Access Compliance Report

Public Rights-of-Way

(Curb Ramps)

Intersection ID: 14294	Main Street: EAST_BV	Cross Street: EUCLID_AV	Location: NE
ADA ID: C0CF7F069E93	Ramp Type: Directional1	Initial Pass/Fail: Pass	Overall Compliance: No
Codes/Mitigation Info/Possible Solution		Field Measurements/Component Compliance	
Severity Score: 7.5

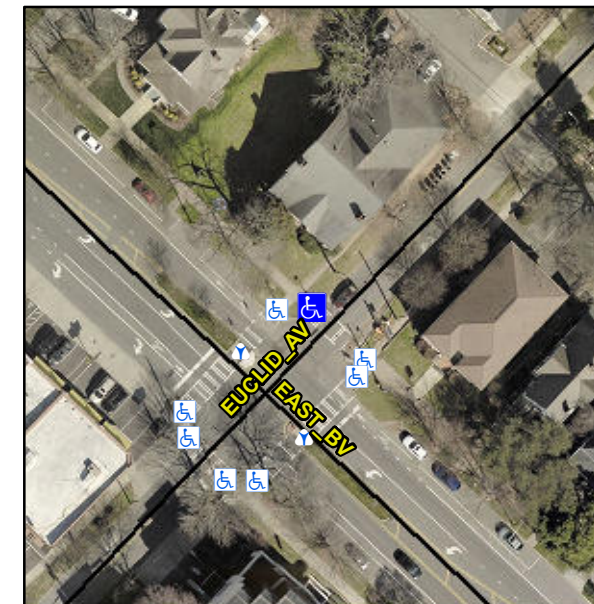
Not Found, R304.5.3, R302.7.2

Compliance	Description	Data	Compliance	Description	Data
N/A	Ramp Length (in)	64.0	Yes	Grade Break?	Yes
Yes	Ramp Width (in)	72.0	No	Grade Break Slope (%)	9.4
Yes	Ramp Slope (%)	2.8	No	Grade Break XSlope (%)	2.7
Yes	Ramp XSlope (%)	0.0			
Yes	Flare Type LT	N/A	Yes	Flare Type RT	N/A
N/A	Flare Slope LT (%)	N/A	N/A	Flare Slope RT (%)	N/A
N/A	Flare Traversable LT?	No	N/A	Flare Traversable RT?	No
Yes	Landing Length (in)	48.0	Yes	DWS Provided?	Yes
Yes	Landing Width (in)	72.0	Yes	DWS Contrast?	Yes
Yes	Landing Slope (%)	0.4	Yes	DWS Length (in)	25.0
Yes	Landing X Slope (%)	0.0	Yes	DWS Full Width?	Yes
N/A	Landing Curb? (Y/N)	No	Yes	DWS Offset LT (in)	2.0
N/A	Shared Landing?	No	Yes	DWS Offset RT (in)	10.0
Yes	Gutter Ponding?	No	Yes	Gutter Slope (%)	2.7
No	Gutter Lip Ht (in)	0.5	Yes	Gutter X Slope (%)	1.4
N/A	Painted X Walk1?	Yes		Road Slope (%)	3.3
	X Walk 1 Direction	To SE		Road X Slope (%)	1.5
	X Walk 1 Width (in)	110.0		Clear Space?	Yes

Remove & Replace Entire Ramp.
